SUBJECT: TURKEY POINT UNITS 3 AND 4 - ISSUANCE OF AMENDMENTS RE: PRESSURE  
AND TEMPERATURE (P/T) LIMITS (TAC NOS. 69390 AND 69391)

ATTACHMENT TO LICENSE AMENDMENT

SAFETY EVALUATION BY THE OFFICE OF NUCLEAR REACTOR REGULATION  
RELATED TO AMENDMENT NO. 134 TO FACILITY OPERATING LICENSE NO. DPR-31  
AND AMENDMENT NO. 128 TO FACILITY OPERATING LICENSE NO. DPR-41

Figure 3.1-1a

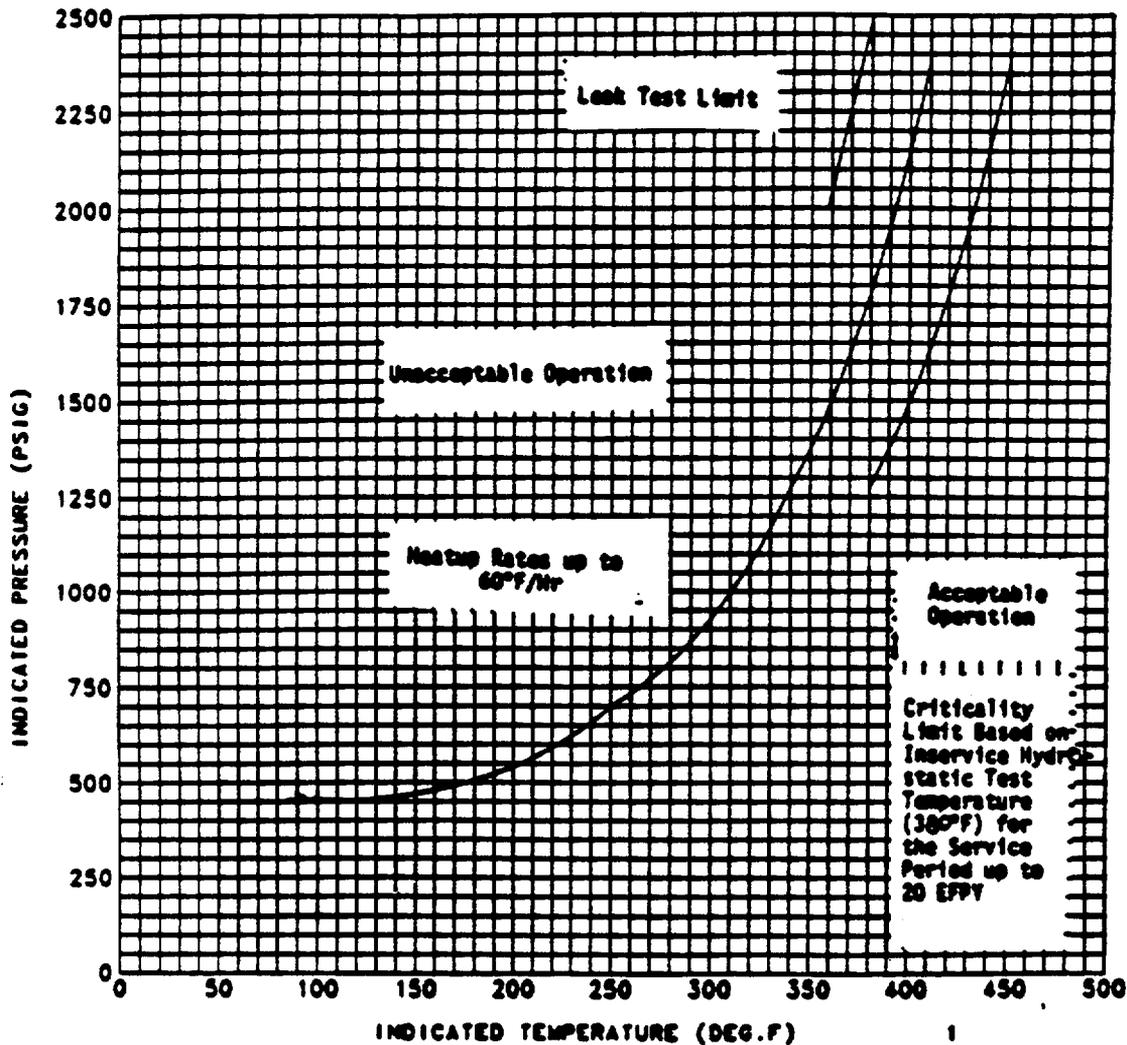
These amendments revise Section 3.1.2 of the TS by incorporating modified P/T limits for the Reactor Coolant System (RCS) and pressurizer. These P/T limits take the form of parametric curves which define the permissible operating envelope during reactor heatup, cooldown, criticality, and inservice leak and hydrostatic testing. Because the P/T limits are based partly on the most limiting nil-ductility temperature for the reactor vessel, it is necessary to periodically revise the limits to account for improved data on the effects of irradiation and other factors on the nil-ductility temperature. The Turkey Point reactor pressure vessel surveillance program provides updated materials data for refining the estimated effects of irradiation on the nil-ductility temperature. The P/T limits currently in the TS are applicable up to 10 effective full power years (EFPY). These amendments replace the P/T curves with revised curves applicable up to 20 EFPY.

3.1.2a The Reactor Coolant System (except the pressurizer) temperature and pressure shall be limited in accordance with the limit lines shown on Figures 3.1-1a, 3.1-1b and 3.1-1c for both Unit 3 and Unit 4 during heatup, cooldown, criticality, and inservice leak and hydrostatic testing with:

CURVES APPLICABLE FOR HEATUP RATES UP TO 60°F/HR FOR THE SERVICE PERIOD UP TO 20 EPFY. NO MARGINS ARE GIVEN FOR POSSIBLE INSTRUMENT ERRORS.
